Development Facilitation Team (DFT) – Review Comments

Project No: PR-2022-006674

Application For: SD-2023-00197-PRELIMINARY/FINAL PLAT (DHO)

Project Name: Lots 16-A and 17-A, Land of Raymond Ortiz

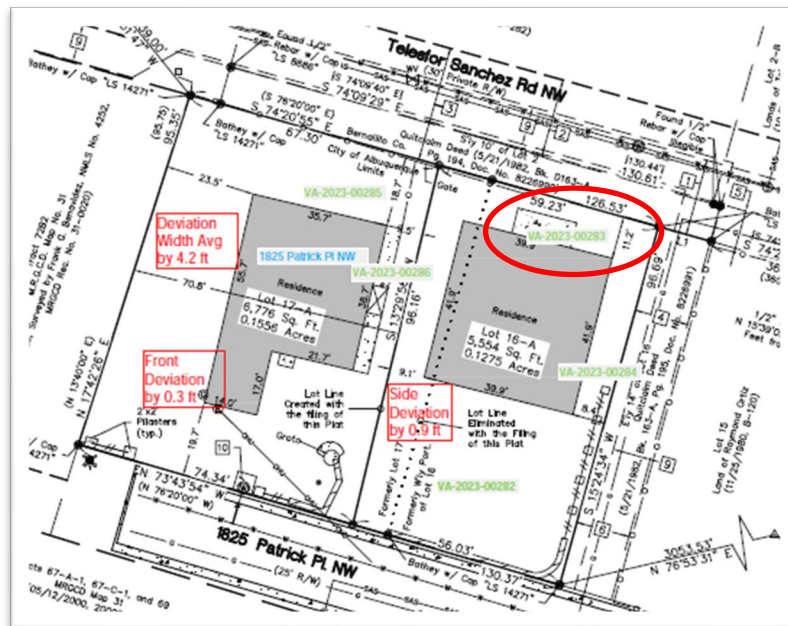
- This proposed Minor Preliminary/Final Plat would adjust the boundary between two existing lots (Lot 16 and Lot 17 of the Land of Raymond Ortiz), creating two new lots (Lots 16-A at 6,776 square feet in size and 17-A at 5,554 square feet in size).
- On December 6, 2023, the Zoning Hearing Officer (ZHE) approved five Variances:
 1. **VA-2023-00282**: Variance of 2 ft. to the required 20 ft. front yard setback for Lot 16-A.

1. Deviation of 0.3 ft. to the required 20 ft. front yard setback for Lot 17-A.

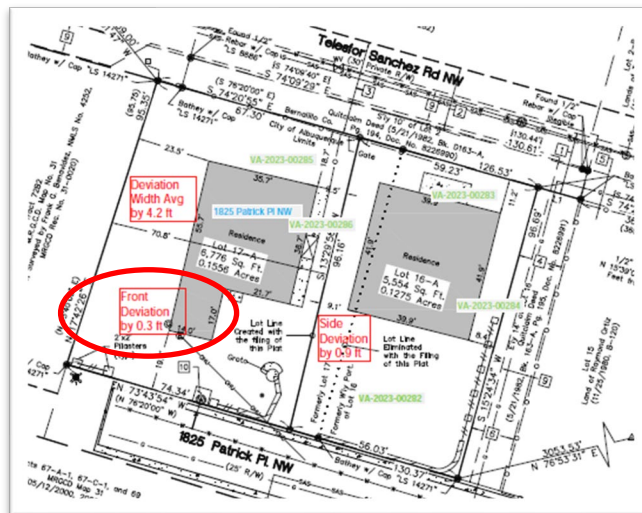
The Deviation is justified per 6-4(O)(3) of the IDO, as it's an existing non-conformity that's not created by the proposed replat. Additionally, the proposed Deviation will not cause material adverse impacts on surrounding properties.

2. Deviation of 0.9 ft. to the required 10 ft. side yard setback for Lot 16-A.

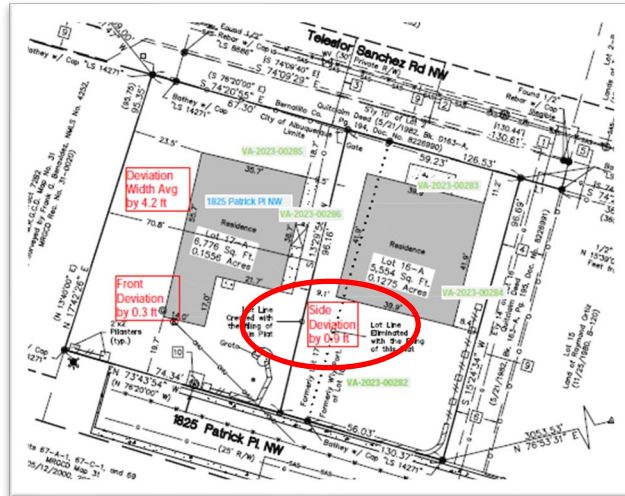
The Deviation is justified per 6-4(O)(3) of the IDO, as the lot line is currently encroaching on the existing residence on Lot 16-A. Moving the lot line further west as proposed will reduce the existing non-conformity. Additionally, the proposed Deviation will not cause material adverse impacts on surrounding properties.

3. Deviation of 4.2 ft. to the required 4.2 ft. for the minimum 75 ft. lot width for Lot 17-A.

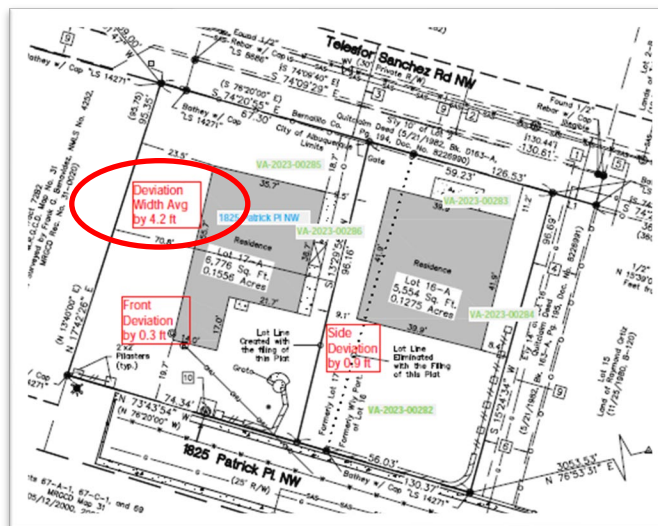
The Deviation is justified per 6-4(O)(3) of the IDO, as the lot line between Lots 16-A and 17-A is currently encroaching on the existing residence on Lot 16-A. Moving the lot line further west as proposed will reduce that existing non-conformity. Additionally, the proposed Deviation will not cause material adverse impacts on surrounding properties.
